TECHNICAL NOTE TN-1185

Addendum to TN-538A (Improving MRF555 and MRF630 Transistor Reliability)

14 June 2006

Figure 1. Location of caps in Series II.

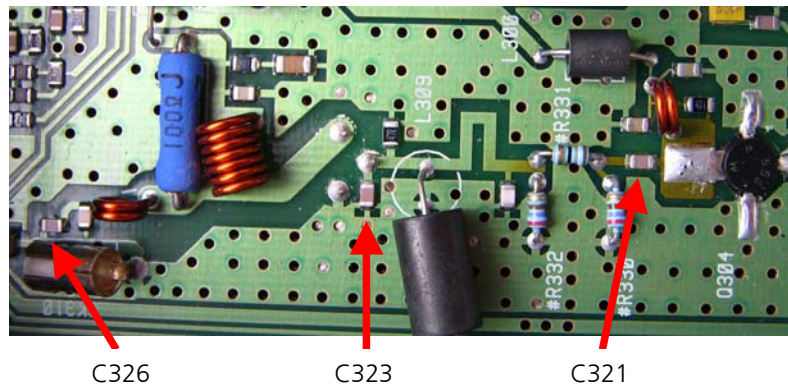
Capacitors to be replaced are C321, C323, & C321 as shown in Figure 1.

C321: 015-22220-01 (CAP cer 22p NPO 50V 5% 0805)

C323: 015-22330-01 (CAP cer 33p NPO 50V 5% 0805)

C326: 015-21470-01 (CAP cer 4p7 ±.25pF 50V 0805)

Figure 2. Location of caps in Series I (Drive Amp cavity)

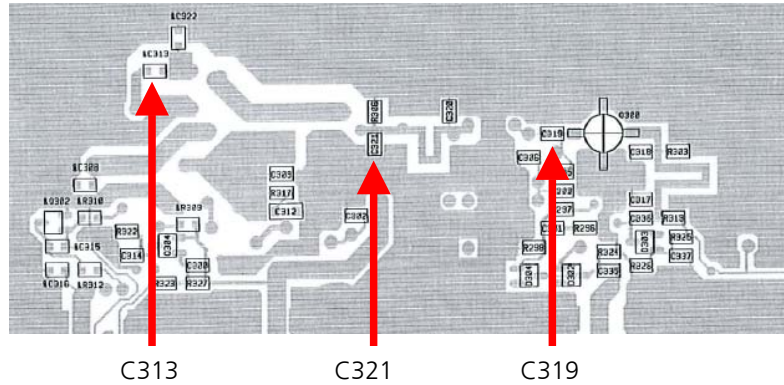
Capacitors to be replaced are C313, C319, & C321 as shown in Figure 2.

C313 & C319: 015-22220-01 (CAP cer 22p NPO 50V 5% 0805)
C321: 015-22330-01 (CAP cer 33p NPO 50V 5% 0805)
